**Subject:** Response to U.S. EPR Design Certification Application RAI No. 293, FSAR Ch. 16 OPEN ITEM, Supplement 2  
**Sent Date:** 7/14/2010 11:42:25 AM  
**Received Date:** 7/14/2010 11:42:30 AM  
**From:** BRYAN Martin (EXTERNAL AREVA)

**QUESTIONS for Technical Specification Branch (CTSB)**

**Figure 16-304-1. Treatment of Accumulation for Main Steam Safety Valves**

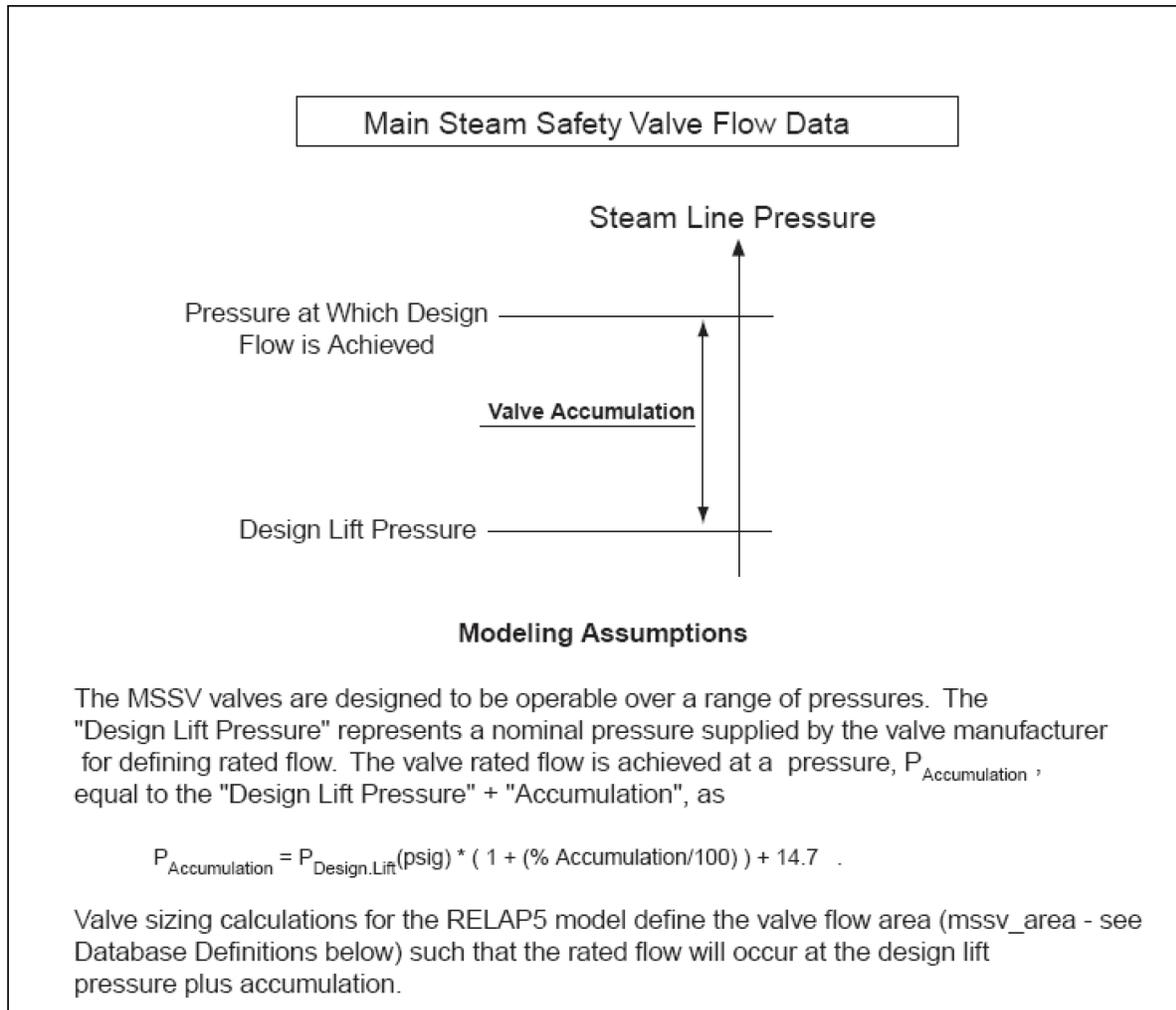
In its response letter dated December 12, 2008, the applicant stated "the flow area of the main steam safety valves is calculated based on rated flow rate being achieved when system pressure is equal to nominal setpoint pressure, plus 3% accumulation. The MSSV setpoint pressure used in the safety evaluation is calculated as the nominal setpoint pressure, plus 3% setpoint uncertainty (to account for drift). Since accumulation and uncertainty have the same value of 3%, rated flow will be achieved at the initial valve opening." The applicant also indicated that no change to the EPR FSAR is needed.

The staff finds the above response unacceptable in that combining an one-sided + 3% accumulation with a two-sided +/- 3% setpoint uncertainty can result in a total of + 6% difference from the nominal setpoint value. The rated lift capacity assumed in the accident analysis should be at the upper limit of the combined tolerance (e.g., at the RCS pressure of 1608.7 psia instead 1518.5 psia for the first MSSV).

The lower and upper main steam safety valves (MSSV) have set pressures of 1460 psig and 1490 psig, respectively. Both MSSVs are attached directly to the main steam line. The U.S. EPR MSSVs use an accumulation of 3% above the set pressure before rated relieving capacity is achieved. This is the accumulation (rated lift) value specified by ASME Code, Section III, Division 1, NC-7512.1(a). A tolerance of  $\pm 3\%$  is utilized in the overpressure analyses to account for potential set pressure drift during plant operation rather than utilizing the less limiting

ASME specified  $\pm 1\%$  tolerance. A  $\pm 1\%$  tolerance is utilized as the "as left" set pressure condition after testing and inspection. Per AREVA response to RAI 293, Question 16-303, justification for the use of a  $\pm 3\%$  tolerance will be included in the U.S. EPR Overpressure Protection Report as required by ASME Code, Section III, Division 1, NC-7512.2(a).

The rated relieving capacity is reached at the set pressure plus accumulation (rated lift). For the U.S. EPR, the rated relieving capacity of the MSSVs corresponds to 25% of 110% of the full power steam flow in each steam line, or 1,422,073 lb<sub>m</sub>/hr.

Figures 16-304-1 and 16-304-2 provide a graphical explanation as to the application of accumulation and tolerance for the main steam safety valves. It should be noted that for the accumulation description, the design lift pressure is equal to the set pressure of the U.S. EPR MSSVs (i.e., 1460 and 1490 psig).
